Product Update Memo

August, 2006

SDTM Series

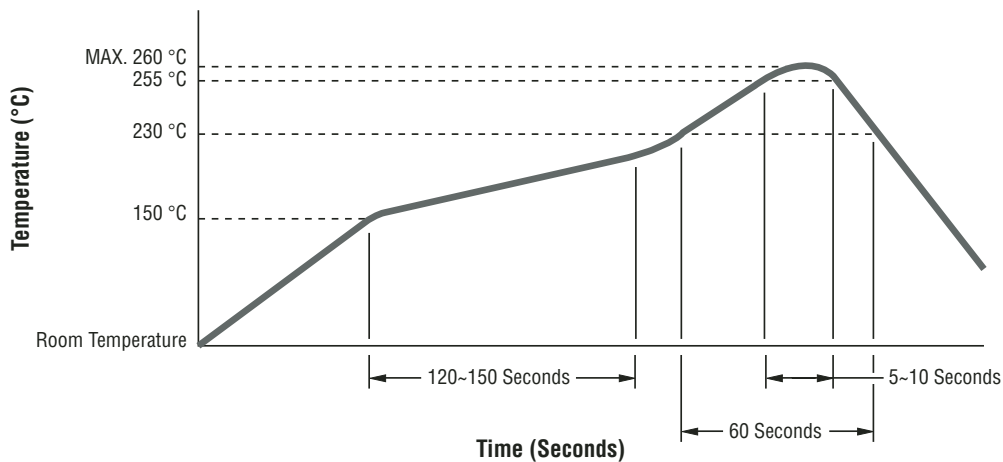
Bourns® Trimpot® Division is updating the housing material used on the [Model SDTM series](#). The new material is lead free process-compatible and brown in color. It is recommended that customers not deviate from the soldering profile in Figure 1. Shipments with the new brown housing material will begin the week of August 28, 2006.
